LAKEPOINT PICKLEBALL COURT COMPLEX – 2026-031-2631

ADDENDUM #1

ROOF FRAMING PLAN
SCALE: 1/4" = 1'-0"

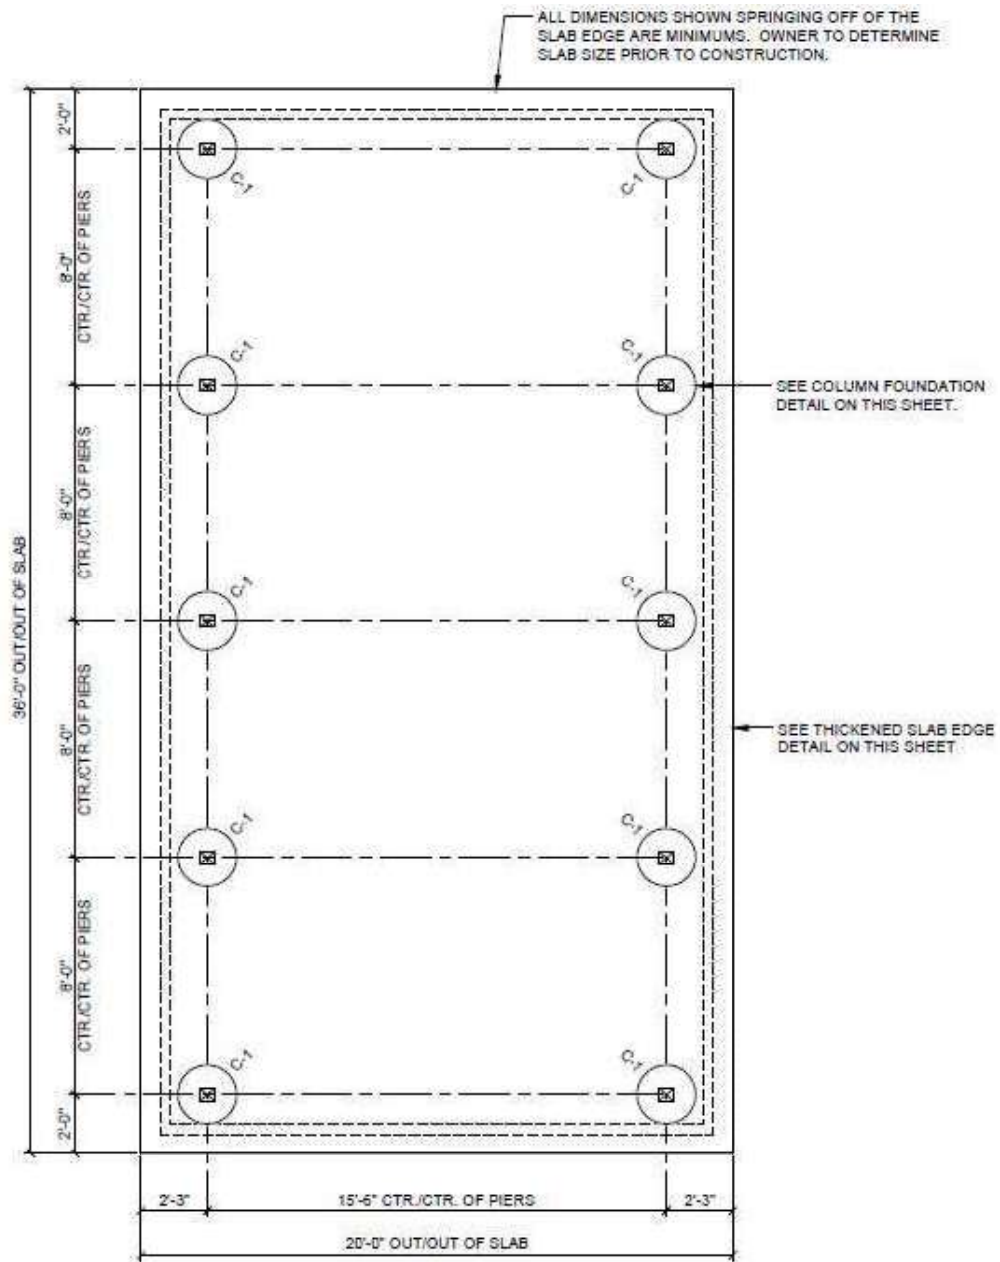
4. Will lighting and electrical outlets be added to the pavilion? Yes. Two (2) – 4 foot outdoor rated LED light fixtures mounted on the three ridge beams (see roof framing plane detail) (6 fixtures total). Two (2) receptacles (120 volt) mounted on the center columns (see Roof Framing plan). One (1) light switch mounted on a corner column post adjacent to the sidewalk. Light switch, receptacles and wiring to be installed in weathertight conduit. Wiring to be installed underground to a stand-alone breaker in the restroom panel. See attached drawings for details of lighting plan.
<https://revolveled.com/products/4-ft-vapor-tight-led-light-fixture-24-0301> or equivalent.

4' Light Fixture

120v Receptacle

Light Switch
